APP-GW-GLN-012, Revision 0
“AP1000 Reactor Internals Design Changes”

WCAP-16716-NP
Revision 0

AP1000 Reactor Internals Design Changes

TITLE: AP1000 Reactor Internals Design Changes

**Figure 3-1 Elevation View of Reactor Bottom Vessel Head, Flow Skirt,
and Lower Core Support Plate**

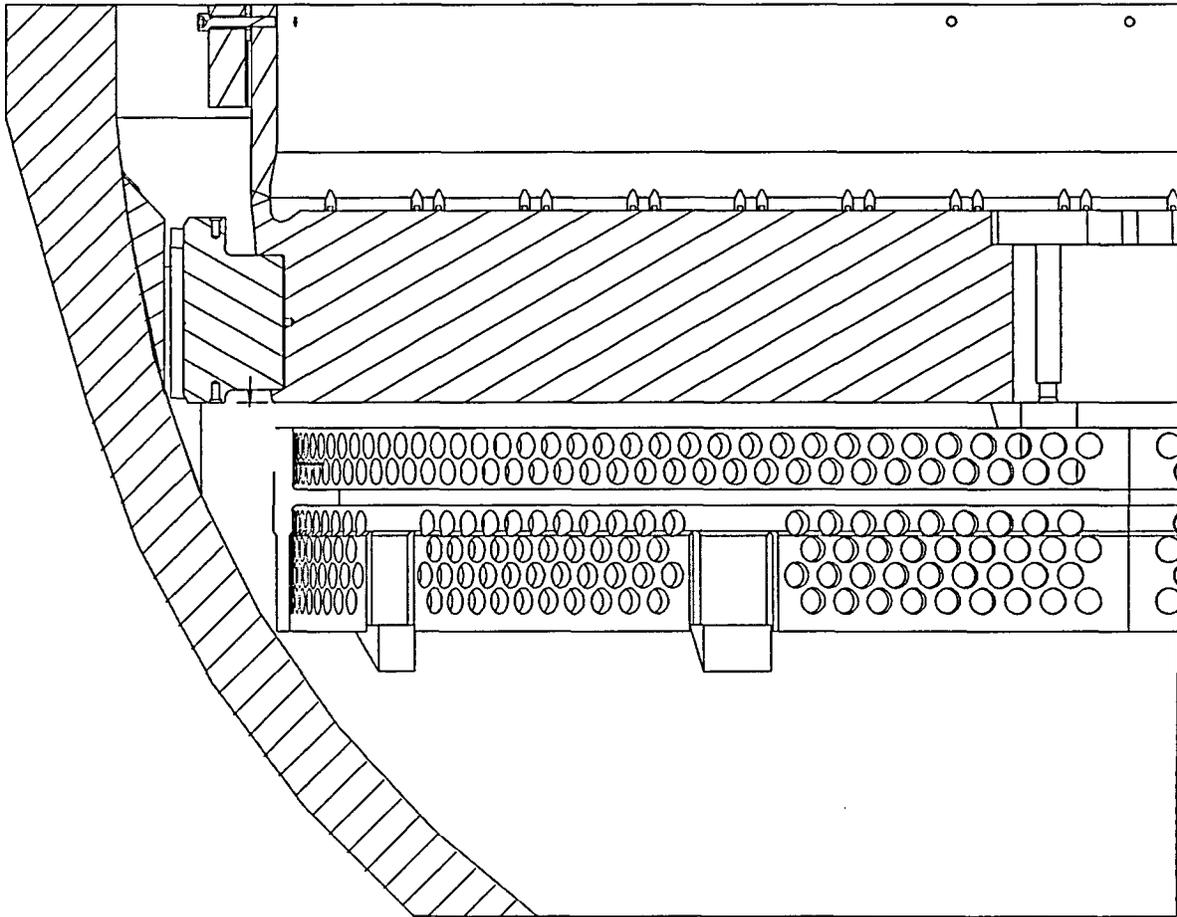
The results of the CFD calculations using the existing structures in the lower plenum along with the LCSP flow hole geometry indicated that the core inlet flow distribution needed to be adjusted to create a more uniform core inlet flow distribution. The core inlet flow distribution was improved by the addition of a flow skirt to the lower plenum of the reactor vessel.

CFD analyses of numerous configurations of the hardware in the lower reactor vessel have been made with the objective of obtaining a core inlet flow distribution that meets specifications established by the Westinghouse fuel group. It has been determined that flow distributions that meet the requirements are obtained with a flow skirt. A flow skirt is a perforated cylinder in the lower reactor vessel head that is attached to the reactor vessel bottom head (See Figure 3-1). The flow skirt is attached to the lower head of the reactor vessel at the plant site after measurements for machining of the core barrel clevises have been completed. The attachment consists of welds across eight tabs that rest on support lugs provided on the reactor vessel lower head.

There is a circumferential weld between the spherical bottom vessel head and the conical transition to the cylindrical portion of the reactor vessel. The weld is just above the top surface of the flow skirt support lugs. There is some radial clearance between the outside of the flow skirt and the inside surface of the reactor vessel at the circumferential weld location. Examination Category B-N-2 of Section XI, Subsection IWB-2500, provides requirements for the visual (VT-3) examination of "interior attachments beyond the beltline region" of the reactor vessel. Vertical access for a pole-mounted camera is possible around the full circumference of the flow skirt with partial blockage at the four lower radial support keys located on the cardinal axes. It has been judged that the flow skirt and attachment welds could be inspected using VT-3 examinations. If any relevant condition is detected, IWB-3122 (prior to service) or IWB-3142 (in-service) provides options for correcting the condition.

Figure 4-1 Changes to Reactor Internals Interface Arrangement (DCD, Figure 3.9-8)

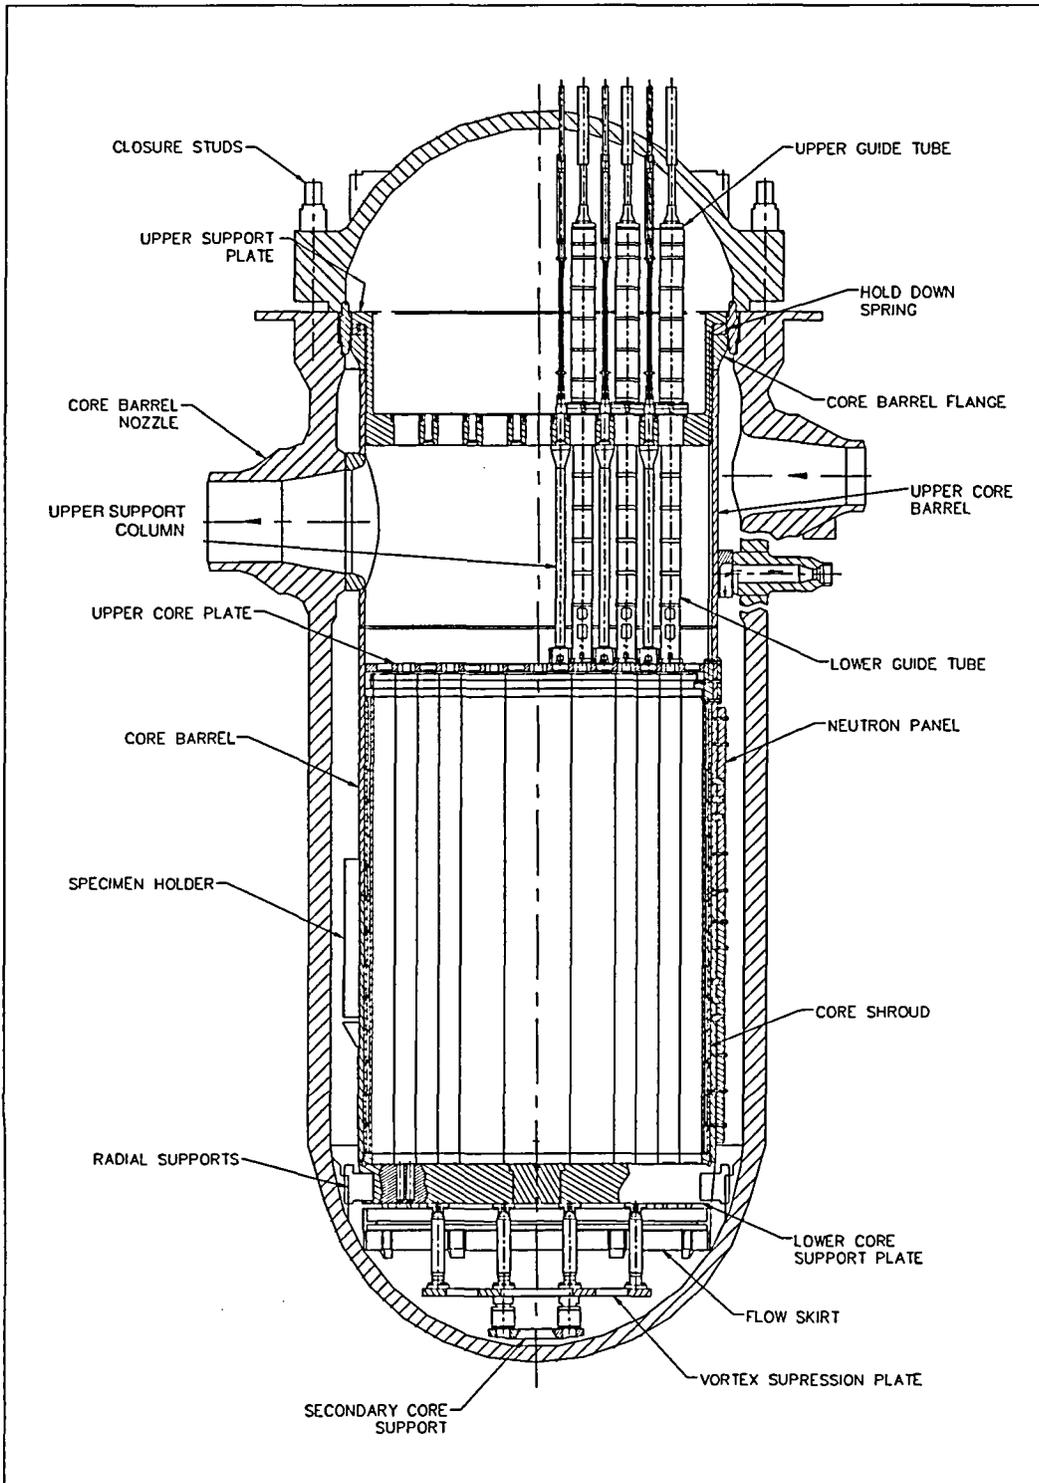
Figure 3.9-8, page 3.9-177 of DCD Revision 15: This figure is modified to show:

- Tapered outer diameter of the lower core support plate
- Neutron panels
- Flow skirt

Figure 4-2 Changes to Reactor Internals Interface Arrangement (DCD, Figure 3.9-5)

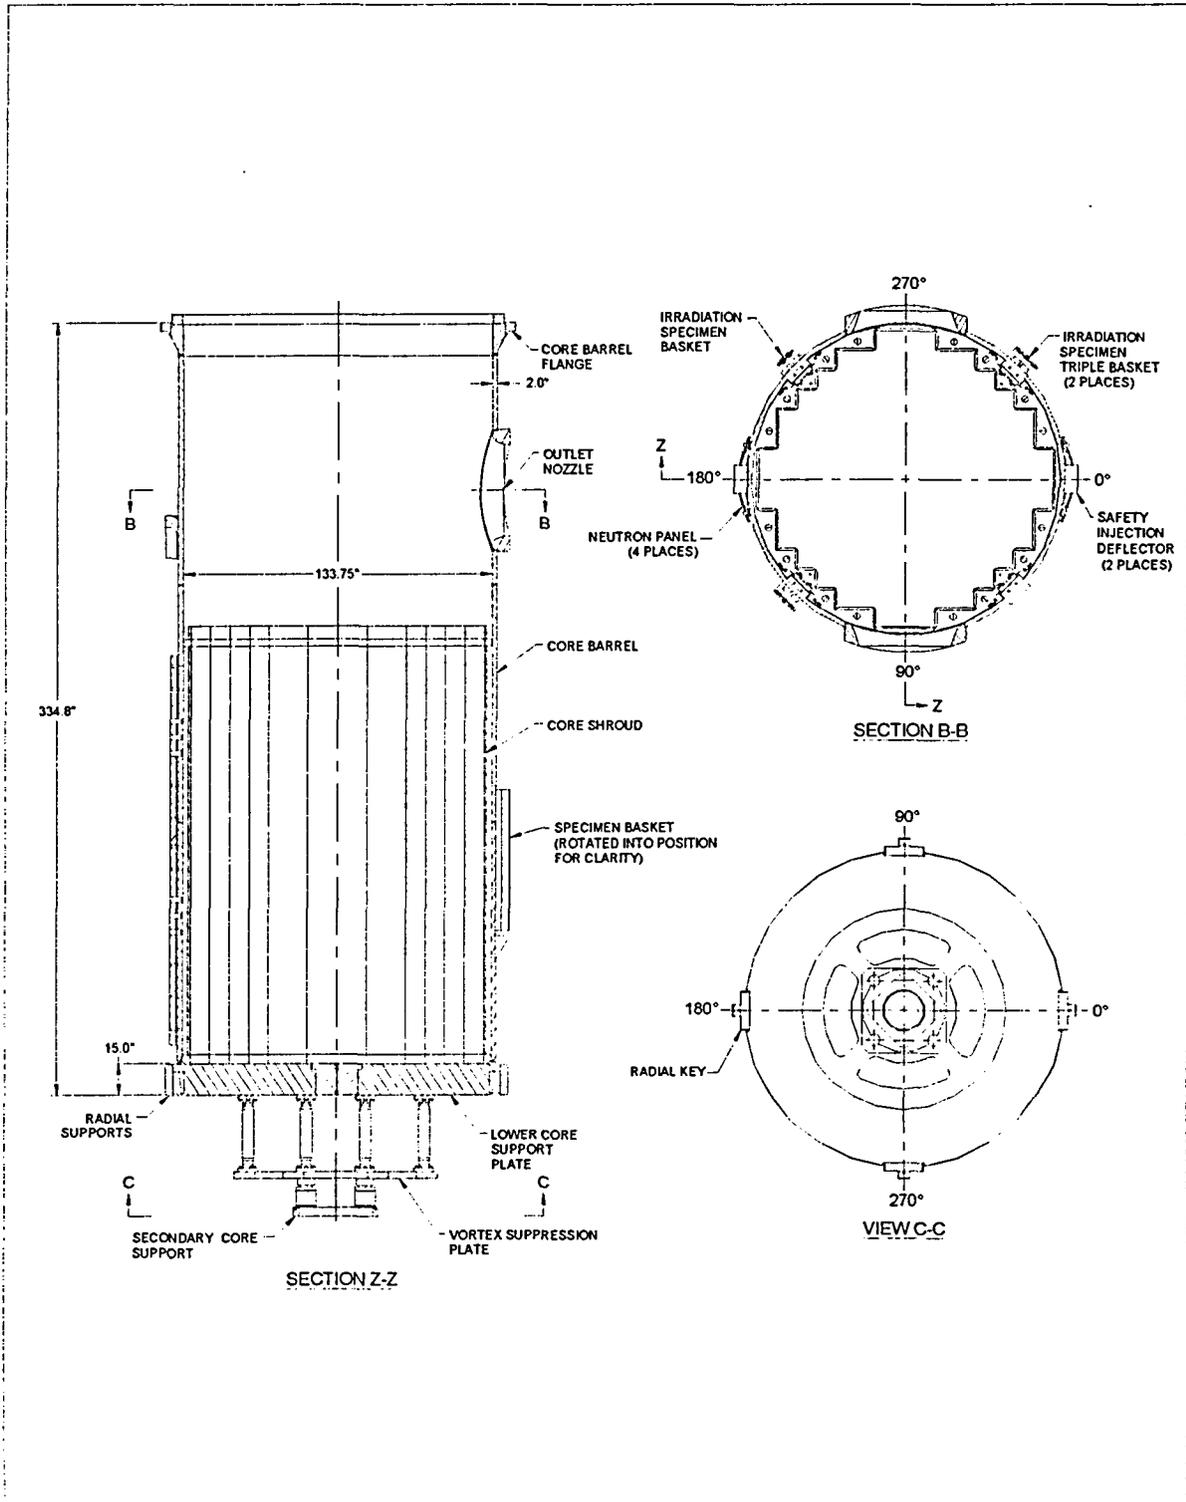
The neutron panels are located at four circumferential locations where fuel assemblies are closest to the reactor vessel (0, 90, 180, and 270 degrees) as shown in Figure 4-2. Each pad covers ~30 degrees circumferentially and extends over the entire length of the active core region (14 feet). The pads are contoured to minimize the impact on the downcomer annulus flow area and to reduce the probability of vortex generation in the downcomer.

Figure 3.9-5, page 3.9-174 of DCD Revision 15: This figure is modified to show:

- A "rotated into position for clarity" statement is added for specimen basket.
- Neutron panels
- Radial keys on cardinal axes, not at 45 degrees
